Project	IEEE 802.16 Broadband Wireless Access Working Group < http://ieee802.org/16 >
Title	Combined figures 500 and 501
Date Submitted	2006-09-25
Source(s)	Peretz Feder - Lucent Technologies [mailto: pfeder@lucent.com]
Re:	
Abstract	Combined Figures 500 and 501
Purpose	Adoption
Notice	This document has been prepared to assist IEEE 802.16. It is offered as a basis for discussion and is not binding on the contributing individual(s) or organization(s). The material in this document is subject to change in form and content after further study. The contributor(s) reserve(s) the right to add, amend or withdraw material contained herein.
Release	The contributor grants a free, irrevocable license to the IEEE to incorporate material contained in this contribution, and any modifications thereof, in the creation of an IEEE Standards publication; to copyright in the IEEE's name any IEEE Standards publication even though it may include portions of this contribution; and at the IEEE's sole discretion to permit others to reproduce in whole or in part the resulting IEEE Standards publication. The contributor also acknowledges and accepts that this contribution may be made public by IEEE 802.16.

Figure 500 – Registration Primitives (MS and BS)

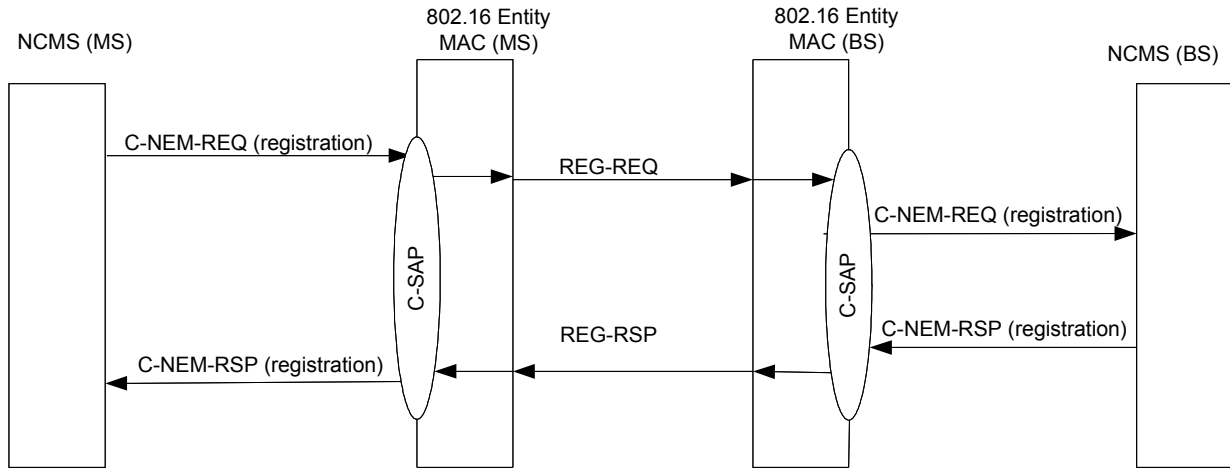
Present end-to-end view of Figures 500 and 501, REG-REQ and REG-RSP

Produce a format that shows end-to-end exchange of REG-REQ and REG-RSP between MS+NCMS and BS+NCMS

In section 14.2.8, combine Figures 500 and 501 per below:
